JRPP PLANNING REPORT

JRPP No:	2012SYW070
DA Number:	1363/2012/JP
Local Government Area:	THE HILLS SHIRE
Proposed Development:	RESIDENTIAL FLAT DEVELOPMENT COMPRISING FOUR BUILDINGS (4 to 7 STOREYS) CONTAINING 147 UNITS AND BASEMENT CAR PARK WITH 366 PARKING SPACES
Street Address:	LOTS 7-9 DP 30744, LOT 1 DP 564845, LOT 6 DP 654751, LOTS 101-104 DP 1000120 & LOT 1 DP 164096 – NOS. 404-416 WINDSOR ROAD & NOS. 1, 2 & 3 MERYLL AVENUE, BAULKHAM HILLS
Applicant/Owner:	MERFAD PTY LIMITED
Number of Submissions:	1 st Notification – 8 2 nd Notification – 3
Recommendation:	APPROVAL
Report by:	DEVELOPMENT ASSESSMENT COORDINATOR CLARO PATAG

ELEVATION DIAGRAM SHOWING BLOCK B EXCEEDING THE HEIGHT LIMITS IN Q1 & N ZONES

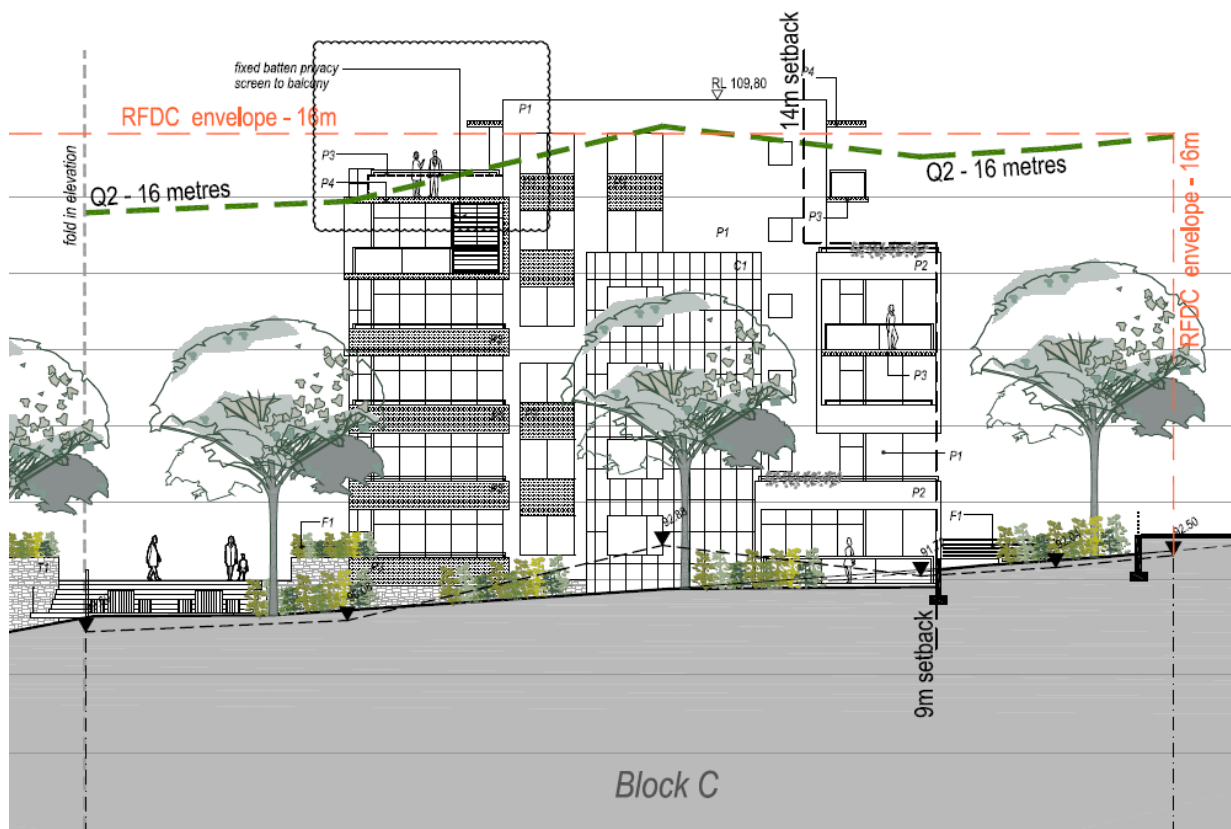
The roof diagram below shows in plan view the extent of non-compliance to the maximum height limits within the Q1 and O2 zones, which is generally between 800mm to 2m in

Block B is located within the Q1 and N height zones, where buildings are restricted to 19m or 6 storey limit and 14m or 4 storey limit respectively. Block B breaches the LEP height limit in Q1 zone by 800mm (4.2%) to 2m (10.5%) and the height limit in N zone partially by 4.5m (32%). When viewed from Windsor Road, Block B will have the same height as the landmark building envisaged in the adopted Planning Proposal at seven storeys.

While Block B proposes to vary the 19m height limit on this portion of the site, it is considered that limiting Block B to a maximum height of 7 storeys will facilitate a more appropriate built form within the Windsor Road Precinct which is of greater consistency with that envisaged within the adopted Planning Proposal.

Figure 32 Windsor Road Precinct – Building Setbacks Key Diagram

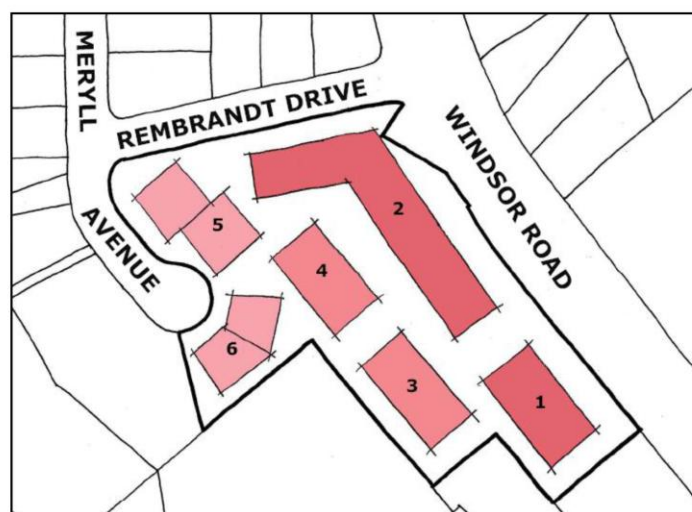
The proposal also seeks variation to the required building setbacks. Table 3.6.5 in the DCP prescribes the minimum setbacks for Building 1 & 2 (Building 1 relates wholly to Block C while Building 2 relates partly to the majority of Block B with the other part extending up to the corner of Windsor Road and Rembrandt Drive, which is located on adjoining properties facing Rembrandt Drive), Building 3 & 4 (Building 3 relates wholly to Block D while Building 4 applies to rear portion of Block B), and Building 5 & 6 (Building 5 relates to future development on the corner of Rembrandt Drive and Meryll Avenue which is not part of this application while Building 6 relates to Block A). The diagram below shows these indicative buildings as depicted in Figure 32 in the DCP.

- *The proposed building designs and built forms are not as illustrated in Figure 32 of Council's DCP - thus demanding a reconsideration of these setback distances;*
- *The sectional view in Figure 33 of Council's DCP is misleading as the frontage to Windsor Road must be elevated to prevent storm-water entry into the site from the street, generating a higher ground level along the street boundary and providing a reduction in the visible heights and floor levels along Windsor Road;*
- *There is no adverse impact on the building separation distances;*
- *There is no adverse impact on solar access to other residential developments;*
- *There is no adverse impact on the amenity requirements for other residential developments.*

Figure 33 Rembrandt Drive & Windsor Road Façade Articulation Zone

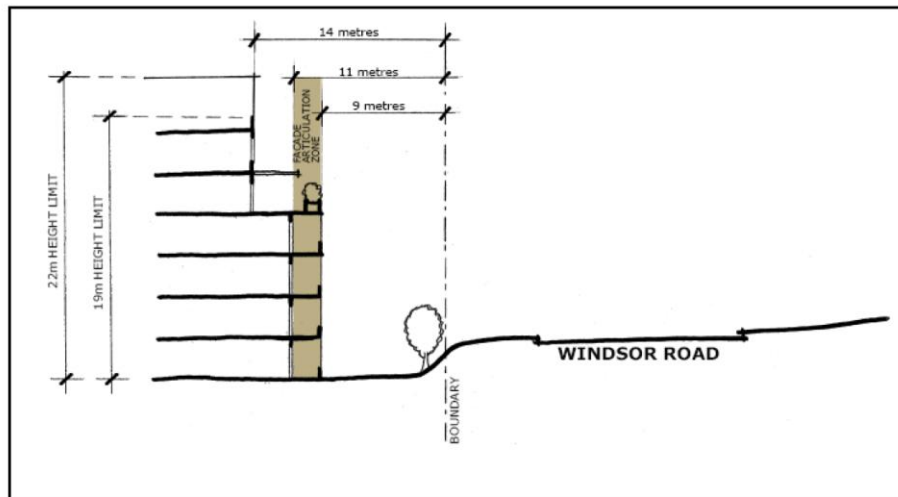
The proposal seeks a variation to the 9 to 11 metres articulation zone for ground to fourth storey fronting Windsor Road and to the 14 metre setback to Windsor Road from fifth to seventh storey. In particular, balconies and bedrooms to Units B31, B32, B35, B36, and B63 to B70 (second to fourth storey within Block B) breach the minimum 9 metre setback by a maximum of 600mm. Balconies and bedrooms within Blocks B and C breach the 14 metre setback required from fifth to seventh storey fronting Windsor Road by a maximum of 4.135m. The diagram below shows the Windsor Road & Rembrandt Drive façade articulation zone as depicted in Figure 33 in the DCP.

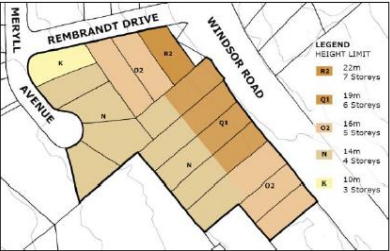
With respect to the orderly development of the remaining land within the Windsor Road Precinct and Council's strategic vision to provide a prominent corner gateway development at the intersection of Rembrandt Drive and Windsor Road, the applicant has prepared a concept masterplan of the Windsor Road Precinct submitted during the Planning Proposal process demonstrating the potential development of a 7 storey residential flat building on the remaining land on the corner of Rembrandt Drive and Windsor Road and a 4 storey residential flat building on the remaining land on the corner of Rembrandt Drive and Meryll Avenue (see diagram below).

Given the fragmented land ownership within the Windsor Road Precinct, the concept master plan demonstrates the development of the remaining land within the Windsor Road Precinct as two separate allotments of only 2,873m² and 1,382m² (rather than one consolidated allotment of 4,255m²). Accordingly, the development of the remaining land within the Windsor Road Precinct in accordance with the concept master plan submitted would require significant variations to the minimum lot size for residential flat buildings of 4,000m². Notwithstanding this, it is considered that the concept master plan demonstrates an acceptable level of consistency with the built form envisaged by the adopted Planning Proposal and demonstrates that a reasonable prominent corner gateway development at the intersection of Rembrandt Drive and Windsor Road of at least 7 storeys could potentially occur.

Accordingly, the proposed variation to the building height standard is considered satisfactory, and the applicant's objection to the standard is supported in this regard.
